# **SUPPLEMENTAL INFORMATION REPORT**

## **CHARLESTON HARBOR POST 45**

### **Part 1. Entrance Channel Design Modifications**

***US Army Corps of Engineers, Charleston District***

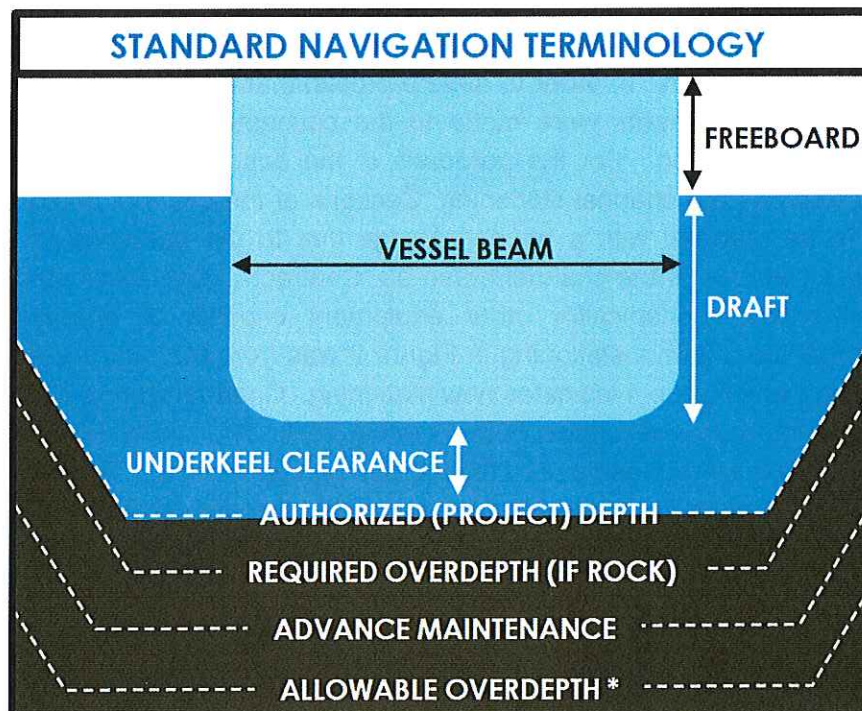
The authorized depth for the entrance channel includes the depth needed for the design vessel to traverse the channel (52-ft) as well as an additional 2-ft for wave allowances (54-ft authorized depth). There are several depth allowances beyond the authorized depth, as defined in the Final IFR/EIS, for new construction (dredging of materials not dredged before to deepen or widen a channel). See Figure 2 for a graphic of these dredging allowances. These allowances include: required overdepth, advanced maintenance, and allowable overdepth. Required overdepth is a design term is used to refer to the need for new construction dredging in channel areas with a hard (rock) bottom to be greater then the authorized depth in order to ensure future maintenance of the project to the authorized dimensions. Advance maintenance is dredging to a specified depth beyond the authorized channel dimensions in critical and fast shoaling areas to avoid frequent re-dredging, in order to ensure the reliability and least overall cost of operating and maintaining the project authorized dimensions. Allowable overdepth is in excess of the required construction depth and allows payment for material dredged below the required construction depth to account for inaccuracies in the dredging process. It is important to make the distinction between required depth and required overdepth. The addition of the required overdepth during new construction provides space for the dredge to operate above the rock bottom during future maintenance activities. While required depth as a construction term refers to the total depth the dredging contractor is required to clear. The required construction depth includes: the authorized depth plus any required design overdepth and/or advanced maintenance. Utilizing these definitions, the project construction depths for the entrance channel recommended from the Final IFR/EIS include: EC-1 required construction depth to 56-ft and allowable overdepth to 58-ft; and EC-2 required construction depth to 55-ft and allowable overdepth to 57-ft (Figure 3).

A design focus of the PED phase was to refine the conceptual plan from the Feasibility study into a detailed plan for construction. In order to have a project that functions as the Recommended Plan intended, some adjustments were made to the conceptual Feasibility template for the Entrance Channel construction. For the purposes of the ensuing discussion, please refer to Figure 4, which indicates the channel stationing. Sections of the channel noted as “Contract 1” are anticipated to be dredged with a hopper dredge due to the presence of unconsolidated materials, whereas sections of the channel noted as “Contract 2” are anticipated to be dredged with a rock cutterhead/mechanical/or other equipment capable of dredging consolidated materials. Note that the channel stationing in Figure 2 was from the old (pre entrance channel extension) stationing and Figure 4 indicates new stationing. Channel station 520+00 from Figure 2 is roughly equivalent to channel station 700+00 in Figure 4. The overall PED updates reduced the volume of material to be dredged during the deepening construction. The below sub-sections document the design changes made in PED to ensure that the authorized project could function as described in the Final IFR/EIS (See Figure 4 which indicates the current channel stationing and the division of the channel into template sections A-D for identification of overdepth requirements).

Figure 4. Proposed modifications resulting from PED phase including channel stationing

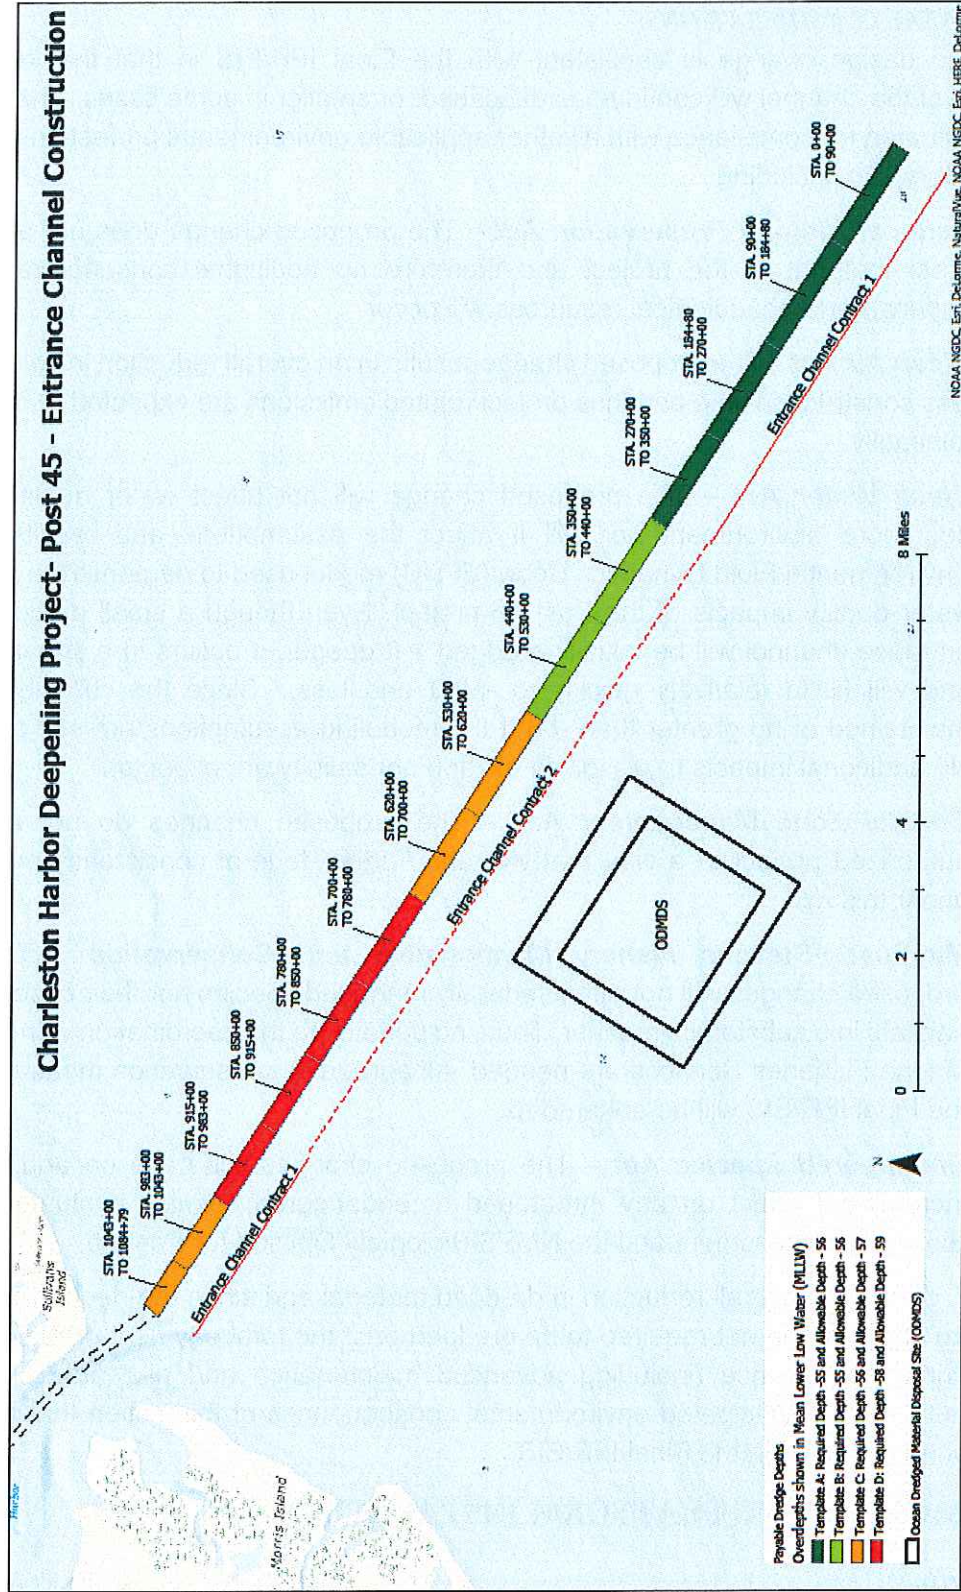
**Template A (Stations 0+00 to 350+00):**

Template A updates included the removal of one foot of required design overdepth since there is no rock in the dredge prism in this area. This reach of the entrance channel is in an area where shoaling is not anticipated, however 1-ft of advanced maintenance is included in the template for

this area to allow for sand waves and some sediment accumulation over time. The Feasibility phase (shown below as the Feasibility Conceptual Template) to PED phase (shown below as the Final Construction Template) refinement in this area is shown below and results in one less foot of dredging.

- i. Feasibility Conceptual Template: 54-ft authorized depth + 1-ft required design overdepth + 2-ft allowable overdepth = 55-ft required depth + 2-ft allowable overdepth = 57-ft total pay depth
- ii. Final Construction Template: 54-ft authorized depth + 1-ft advanced maintenance + 1-ft allowable overdepth = 55-ft required depth + 1-ft allowable overdepth = 56-ft total pay depth

**Template B (Stations 350+00 to 530+00):**

This reach of the entrance channel is in a non-shoaling, consolidated (rock) area. The Feasibility phase to PED phase change in this area is shown below and results in one less foot of dredging.

- i. Feasibility Conceptual Template: 54-ft authorized depth + 1-ft required overdepth + 2-ft allowable overdepth = 55-ft required depth + 2-ft allowable overdepth = 57-ft total pay depth
- ii. Final Construction Template: 54-ft authorized depth + 1-ft required design overdepth + 1-ft allowable overdepth = 55-ft required depth + 1-ft allowable overdepth = 56-ft total pay depth

**Template C (Stations 530+00 to 700+00 and 983+00 to 1084+79):**

Station 530+00 to 700+00 is a low shoaling area with rock bottom. A shoaling analysis showed the presence of slower forming shoals in this area indicating that future maintenance dredging will be required. By moving 1-ft of allowable overdepth to the required depth, the channel is guaranteed 56-ft of rock being cleared which will allow for at least 54-ft authorized depth + 2 ft allowable overdepth during future maintenance dredging. Station 983+00 to 1084+79 is a low shoaling area with an unconsolidated bottom between the Jetties. Although the internal breakout of the different depth functions has changed from the Feasibility phase, there is no change in the total pay depth that may be dredged in these areas.

- i. Feasibility Conceptual Template: 54-ft authorized depth + 1-ft required overdepth + 2-ft allowable overdepth = 55-ft required depth + 2-ft allowable overdepth = 57-ft total payable depth that may be dredged
- ii. Final Construction Template (530+00 to 700+00): 54-ft authorized depth + 1-ft required overdepth + 1-ft advanced maintenance + 1-ft allowable overdepth = 56-ft required depth + 1-ft allowable overdepth = 57-ft total pay depth
- iii. Final Construction Template (983+00 to 1084+79): 54-ft authorized depth + 2-ft advanced maintenance + 1-ft allowable overdepth = 56-ft required depth + 1-ft allowable overdepth = 57-ft total pay depth

**Template D (Stations 700+00 to 983+00):**

Station 700+00 to 915+00 is a shoaling, consolidated (rock) area, and Station 915+00 to 983+00 is a shoaling, unconsolidated area. The Feasibility phase to PED phase change in this area is shown below and results in one more foot of dredging.

- i. Feasibility Conceptual Template: 54-ft authorized depth + 2-ft advanced maintenance + 2-ft allowable overdepth = 56-ft required depth + 2-ft allowable overdepth = 58-ft total pay depth
- ii. Final Construction Template: 54-ft authorized depth + 2-ft advanced maintenance + 2-ft required overdepth + 1-ft allowable overdepth = 58-ft required depth + 1-ft allowable overdepth = 59-ft total pay depth

In summary, these design considerations result in roughly 12 miles of channel being 1-ft shallower than the Feasibility plan, roughly 3.2 miles having no change in total depth from the Feasibility plan, and roughly 5.3 miles being 1-ft deeper than the Feasibility plan for initial construction. The areas that are dredged 1-ft deeper will have no long term affect on water quality because they are in shoaling areas and will only be maintained to -58-ft for any operations and maintenance contracts. Maximum maintenance of the channel most likely will be as follows (total pay depth) though unconsolidated areas may be maintained up to 58' if necessary as per the project authorization:

- i. Station 0+00 to 530+00: -55-ft
- ii. Station 530+00 to 700+00: -56-ft
- iii. Station 700+00 to 983+00: -58-ft
- iv. Station 983+00 to 1084+00: -56-ft

Overall, it is anticipated that dredging volumes during new work construction will be decreased by approximately 588,000 Cubic Yards.
